## PLANNING APPLICATION NUMBER: P12/0866

Type of approval sought	Full Planning Permission
Ward	Gornal
Applicant	Mr P. Stone
Location:	<b>1 CHAPEL WALK, LOWER GORNAL, WEST MIDLANDS, DY3 3NJ</b>
Proposal	<b>PART A: NEW 1.8M HIGH BOUNDARY WALL (RETROSPECTIVE). PART B: TWO STOREY FRONT/SIDE EXTENSION (PART RETROSPECTIVE). (RESUBMISSION OF APPROVED APPLICATION P11/0808).</b>
Recommendation Summary:	<b>PART APPROVE &amp; PART REFUSE (SPLIT DEC'N)</b>

**PERIMETER WALL DETAIL**

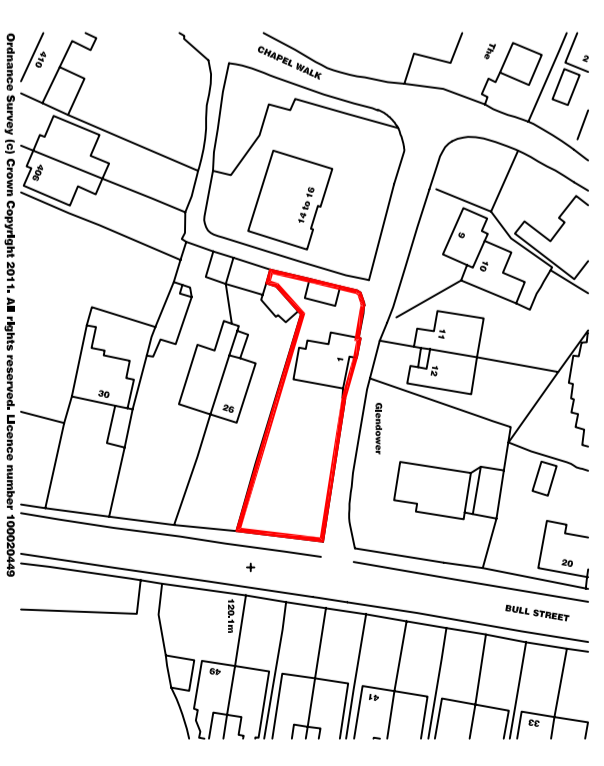
8. The boundary wall is the same height as the recent approval (1.8m high and 2.1m high to the top of the pillars), but is constructed from reclaimed brick, instead of being coated with render on the elevation facing Bull Street. Two new openings have been formed in the wall, comprising a pedestrian access off Bull Street and vehicular access off Chapel Walk (0.5m from the junction with Bull Street). A hardcore parking surface has also been provided to accommodate 2 cars.

11. **Group Engineer, Development:** Generally no driveways should enter at the bellmouth of a junction. A distance of 6 metres should be maintained between the junction and the close edge of the footway crossing. The proposed vehicular access fails to comply with this distance. Positioning footway crossing so close to junctions creates highway safety concerns for:

- Vehicles performing access/egress manoeuvres in close proximity to the junction where the possibility for conflict with other vehicles and pedestrians is greatest,
- Vehicles turning into the side road will not have sufficient time to react if a vehicle is leaving the driveway.

12. The vehicular access serving the parking spaces cannot maintain the 2 metre (m) (X-distance) by 17m (Y-distance) visibility splay required upon exit from the driveways due to a physical obstruction to the splay by the 1.8m high boundary wall. This lack of visibility of vehicles on Chapel Walk and those turning left from Bull Street raises highway safety concerns to an unacceptable level. Junction visibility splays are outlined in Manual for Streets, Table 7.1 & Fig 7.18.

19. The Group Engineer, Development objects to the proposal on the grounds that the driveway visibility splay is obstructed by the 1.8m high wall. As the entrance point is within close proximity to the junction with a busy road, it is considered that the vehicular access in the wall would have an unacceptable impact upon highway safety. As such the proposal is contrary to saved policy DD4 of the UDP.

**PART A:** New 1.8m high boundary wall: REFUSE. The obstructed visibility splay of the vehicular entrance point, within close proximity to the junction with Bull Street would have an unacceptable impact upon highway safety. As such the proposal is contrary to saved policy DD4 of the UDP.

1. The obstructed visibility splay of the vehicular entrance point, within close proximity to the bellmouth of the junction with Bull Street would have an unacceptable impact upon highway safety. As such the proposal is contrary to saved policy DD4 of the UDP.
